Subject: <p style="text-align: center;">DIRT ACCUMULATION ON SIDE SILL</p>	Bulletin No: 09-044/06
	Last Issued: 11/03/2006

2007 CX-7 vehicles with VINs lower than JM3ER****7*138083 (produced before September 11, 2006)

1720a

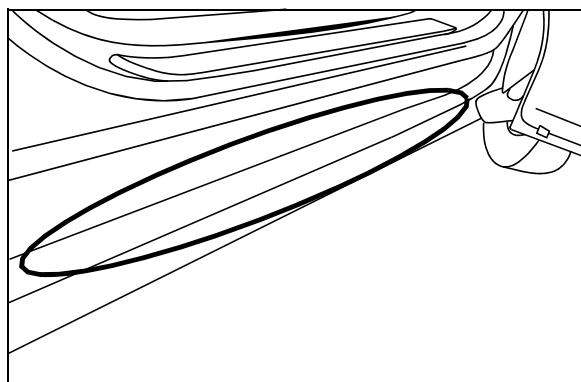
On some vehicles, dirt or debris may accumulate on the side sill and get the customer's clothing dirty when they enter or exit the front or rear doors of the vehicle.

Due to the shape of the rubber seal attached to the side step, dust may easily enter the side sill area and accumulate there.

1720b

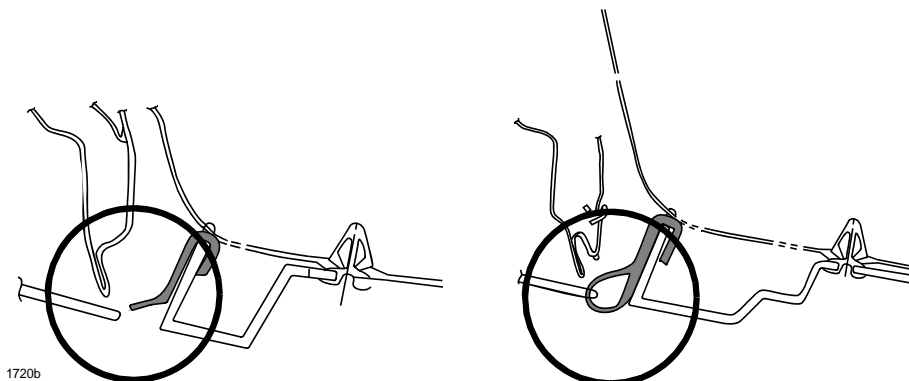
The shape of the rubber seal has been changed during mass-production.

CURRENT TYPE

NEW TYPE

1. Verify customer concern.
2. Replace both left and right side steps with modified parts.
NOTE: Side step covers front and rear door side sill areas.
3. Verify repair.

Part Number	Description	Qty.
EG51-51-P40	Side Step (R)	1
EG51-51-P50	Side Step (L)	1
